# SAN FRANCISCO PLANNING DEPARTMENT

## DRAFT Planning Commission Motion NO. M-XXXXX

*Hearing Date:* August 24, 2017  
*Case No.:* **2014-001272ENV**  
*Project Title:* **Pier 70 Mixed-Use District Project**  
*Zoning:* M-2 (Heavy Industrial) and P (Public)  
40-X and 65-X Height and Bulk Districts  
*Block/Lot:* Assessor's Block 4052/Lot 001, Block 4111/Lot 004  
Block 4120/Lot 002, and Block 4110/Lots 001 and 008A  
*Project Sponsor:* David Beaupre/Port of San Francisco  
[david.beaupre@sport.com](mailto:david.beaupre@sport.com), (415) 274-0539  
Kelly Pretzer/Forest City Development California, Inc.  
[KellyPretzer@forestcity.net](mailto:KellyPretzer@forestcity.net), (415) 593-4227  
*Staff Contact:* Melinda Hue – (415) 575-9041  
[melinda.hue@sfgov.org](mailto:melinda.hue@sfgov.org)

### ADOPTING FINDINGS RELATED TO THE CERTIFICATION OF A FINAL ENVIRONMENTAL IMPACT REPORT FOR THE PROPOSED PIER 70 MIXED-USE DISTRICT PROJECT.

**(NEW) FIGURE 4.D.2A: 1900 SANBORN FIRE INSURANCE CO. MAP**

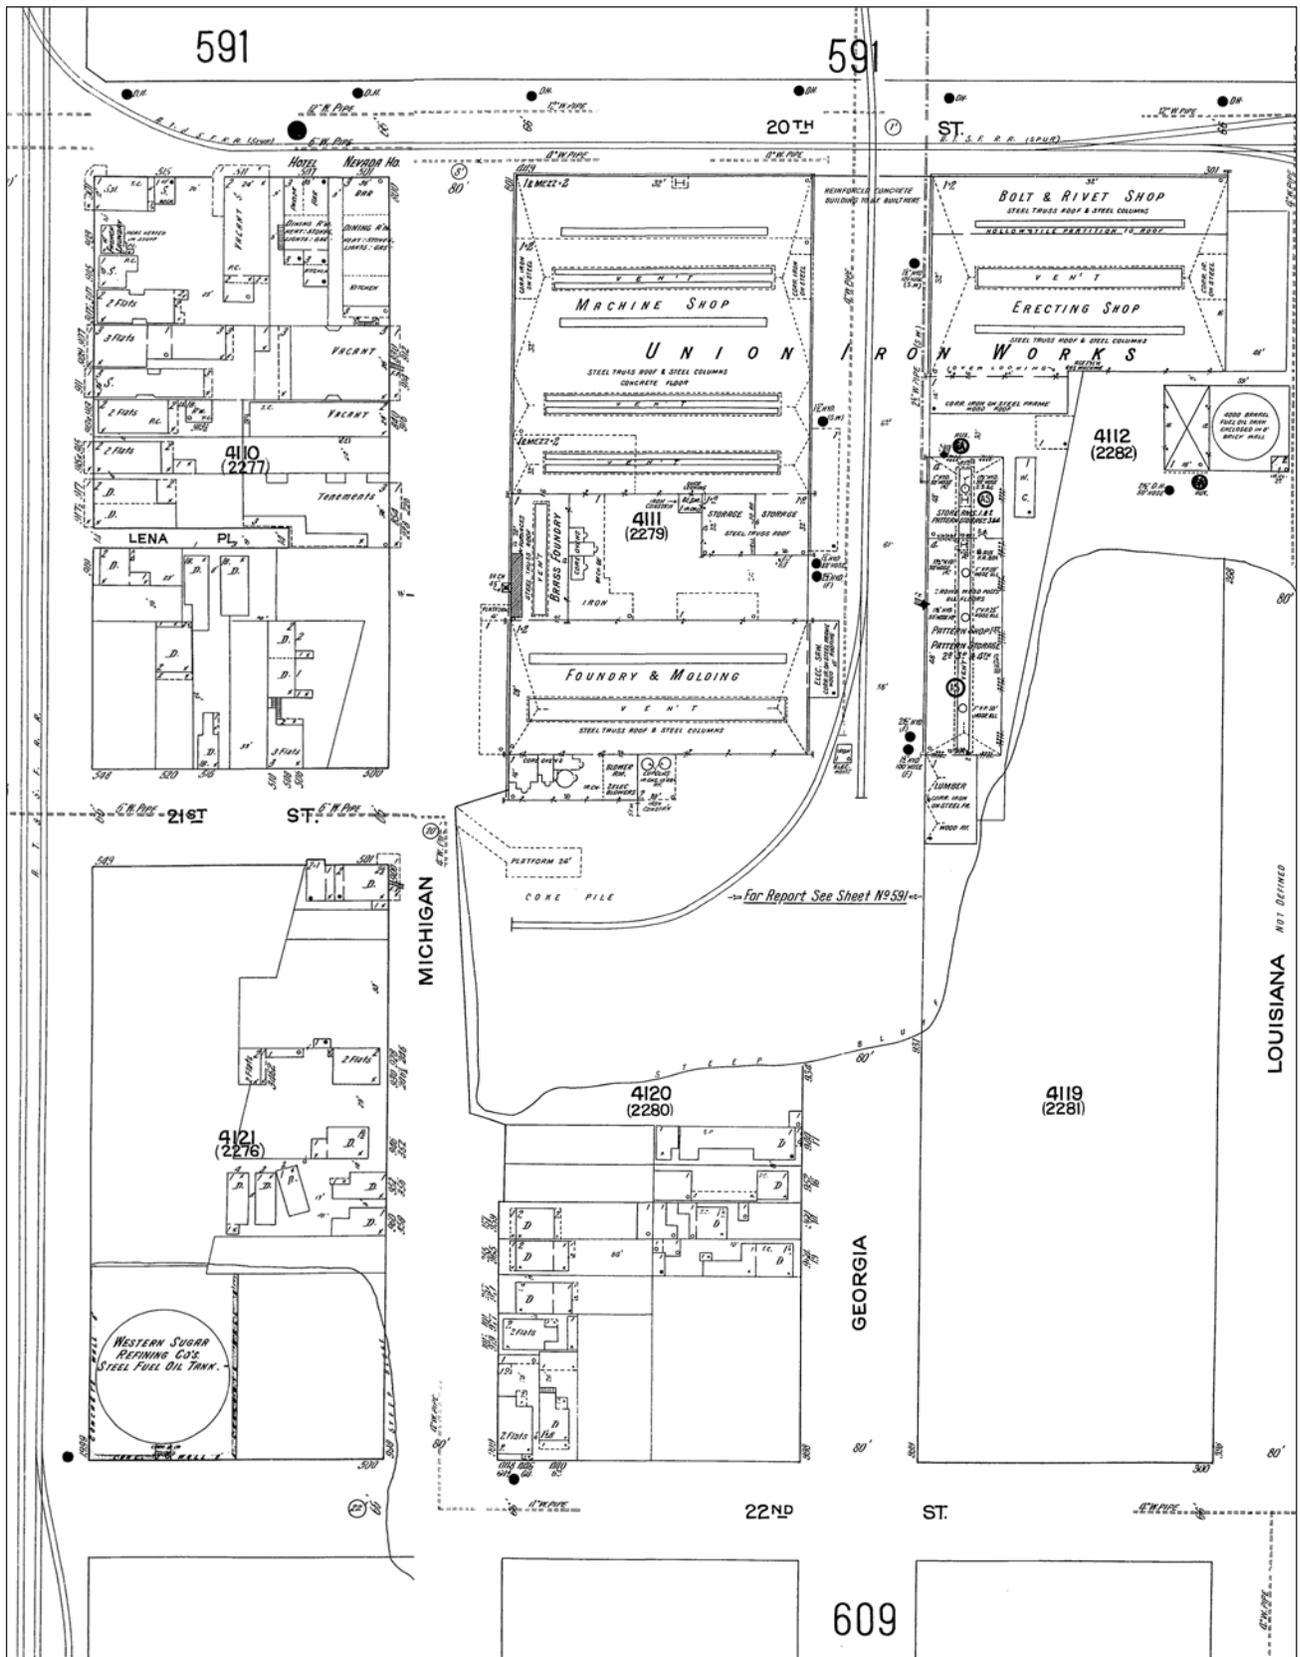
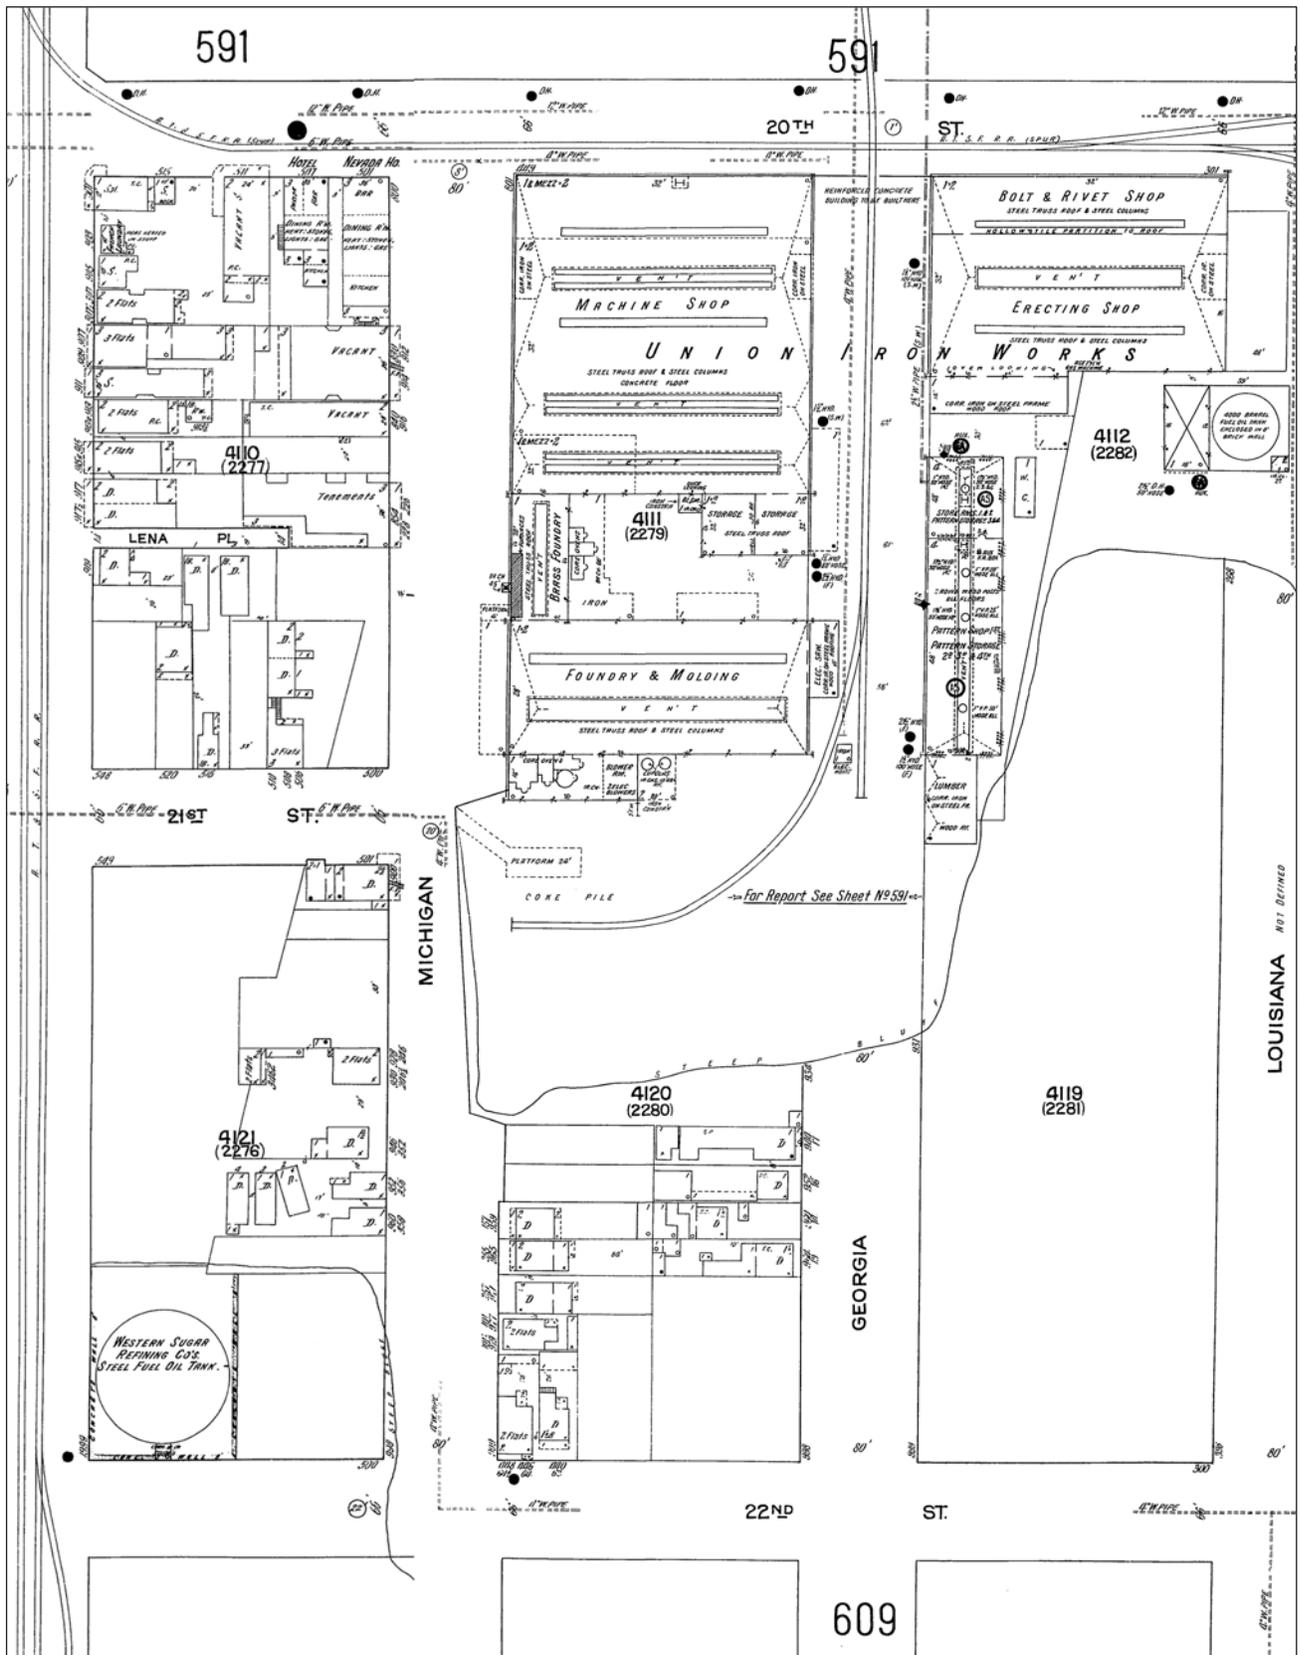
See Figure 4.D.2a: 1900 Sanborn Fire Insurance Company Map, in which multiple 1900 Sanborn maps are stitched together. These streets, which extended the block pattern established west of Illinois Street, appear to have in fact been interrupted by the steep banks of Irish Hill, with development to the north and south of the incline. The east end of 21<sup>st</sup> Street terminated at Michigan Street and was not extended into the site. At the time, Irish Hill hosted a small neighborhood. A mix of lodging houses, dining rooms, and saloons were located near 20<sup>th</sup> Street in the northern half of the block between Illinois and Michigan streets, while small single-family dwellings were clustered near 22<sup>nd</sup> Street in the two blocks bound by Illinois, Michigan, and Georgia streets.

**(NEW) FIGURE 4.D.2B: 1914 SANBORN FIRE INSURANCE CO. MAP**

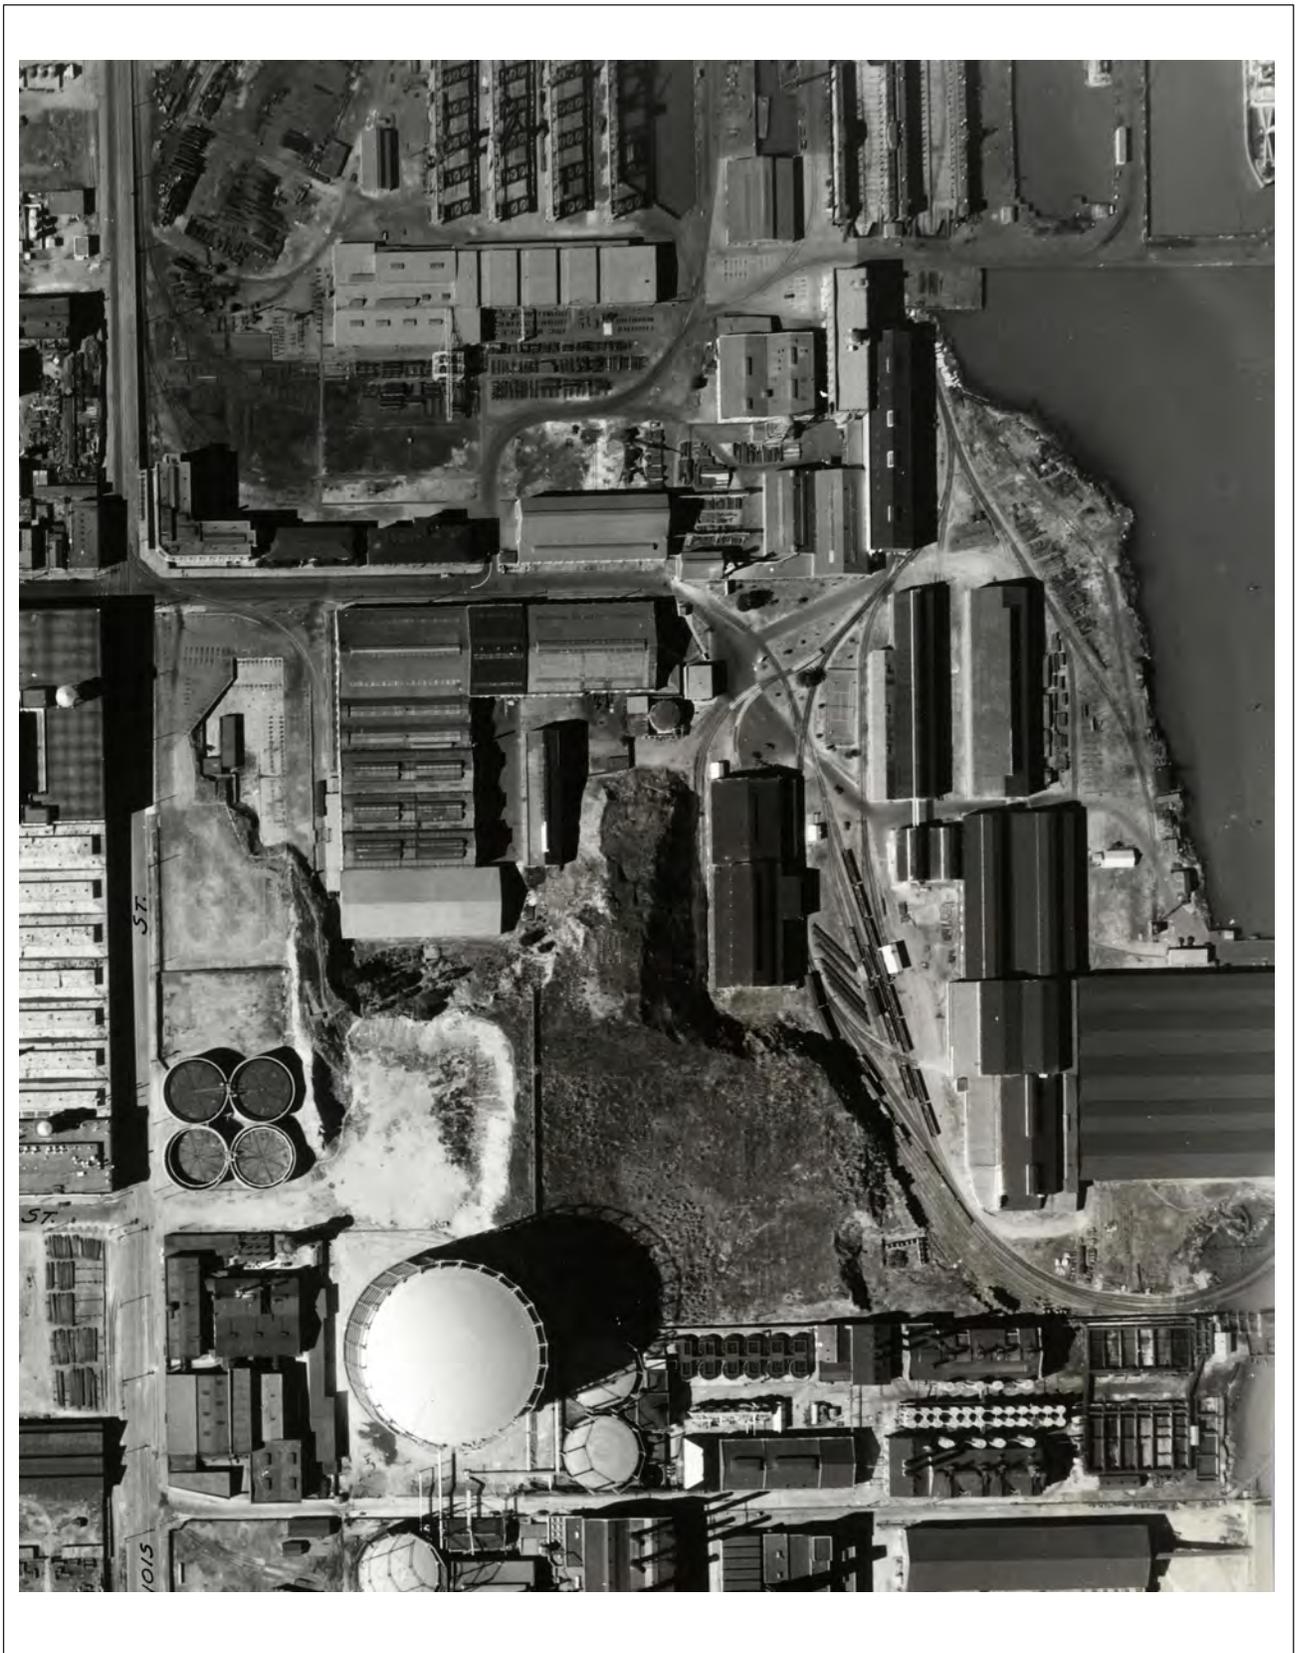
The 1914 Sanborn of the same area, Figure 4.D.2b: 1914 Sanborn Fire Insurance Company Map, shows the partial erosion of this street network, with Maryland Street hosting two railroad lines serving the U.S. Steel operation and the north end of Louisiana Street right-of-way occupied by two new buildings. In addition, roughly half of the Irish Hill residential buildings near 22<sup>nd</sup> Street had been removed by this time. In the subsequent war-time build-up of the site, the remaining buildings, along with the lodging

(NEW) FIGURE 4.D.2C: 1938 AERIAL PHOTOGRAPH OF SITE

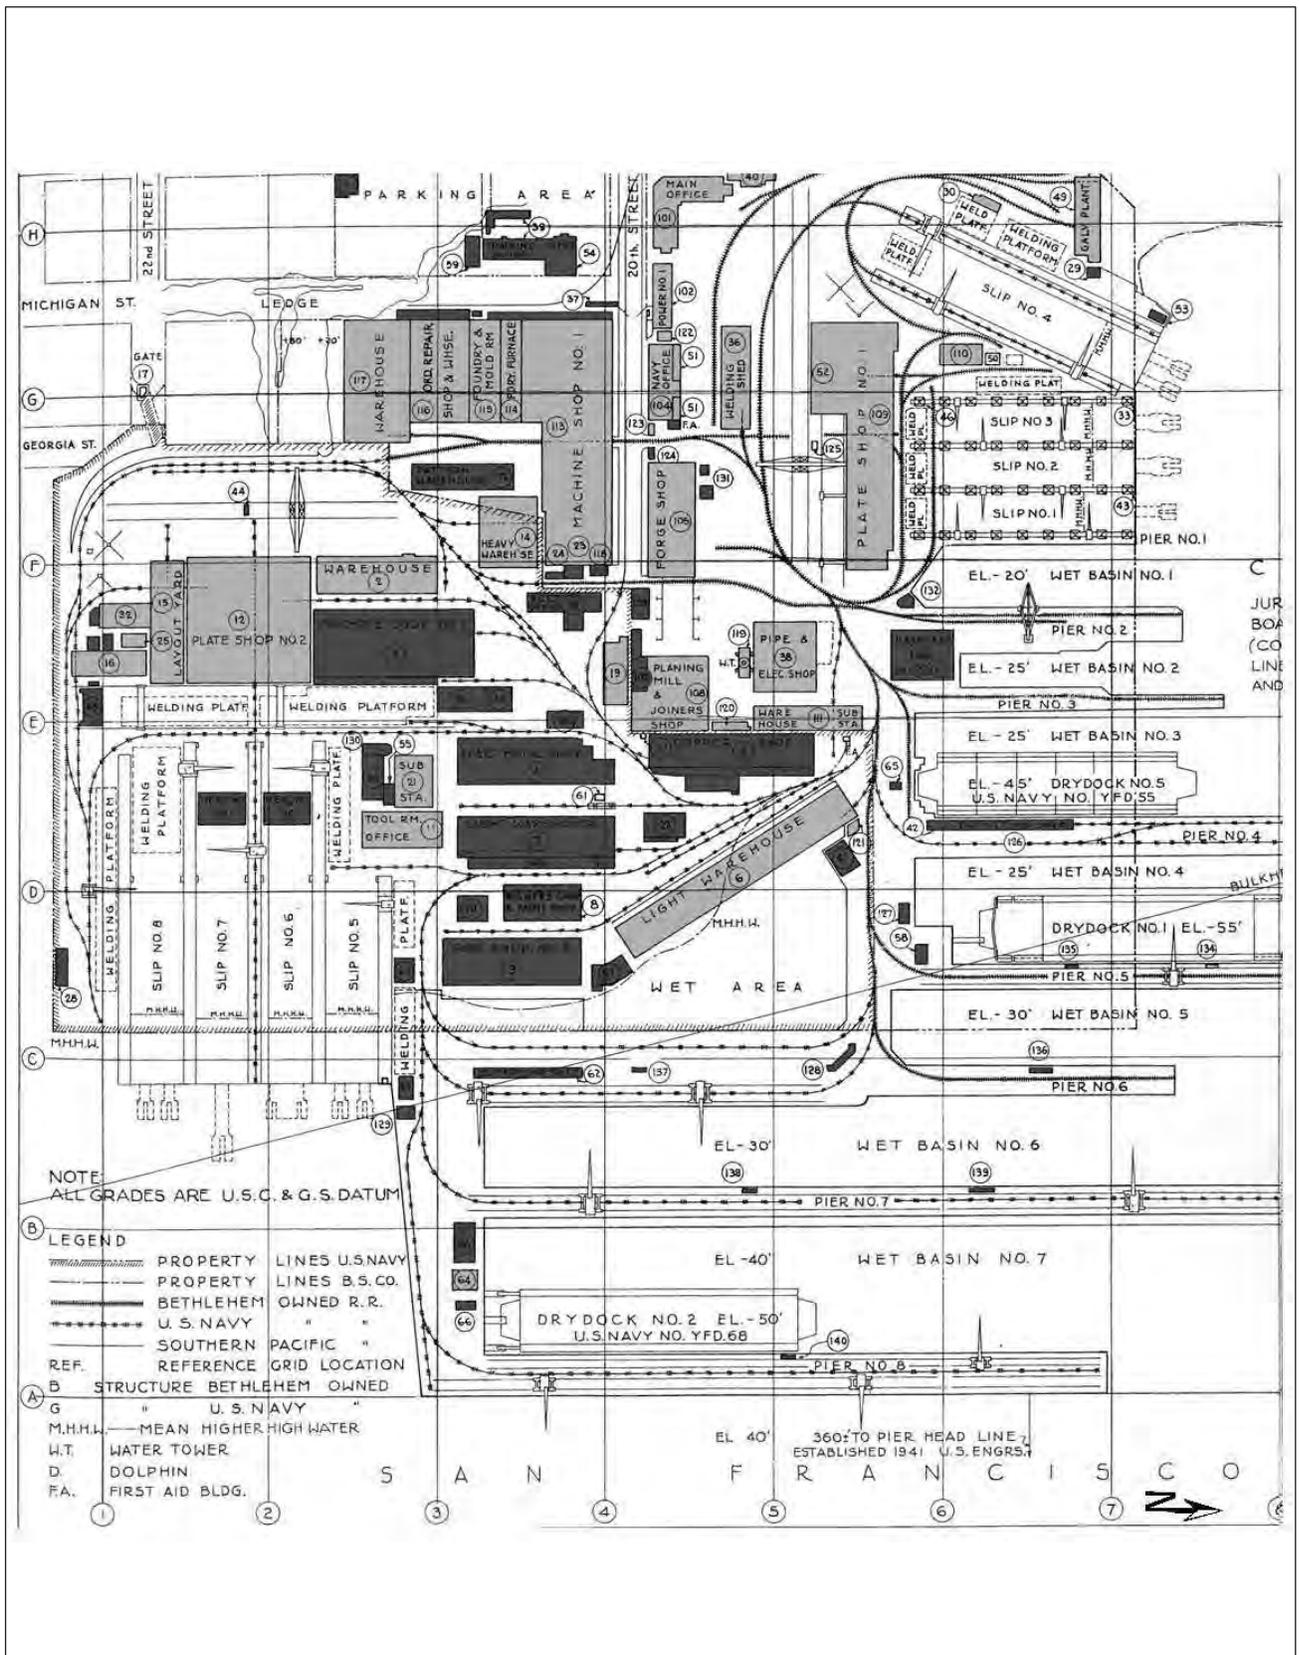
The 1938 aerial of the site, Figure 4.D.2c: 1938 Aerial Photograph of Site, shows the District immediately prior to its World War II-era build-up.<sup>17A</sup> By this time, little reference remained to the “state” streets east of Illinois Street. The northern portions of Michigan and Georgia streets had been reduced to small segments immediately east and west of the Buildings 113-116 complex, while Louisiana and Maryland streets were used for site circulation and largely given over to railroad tracks.
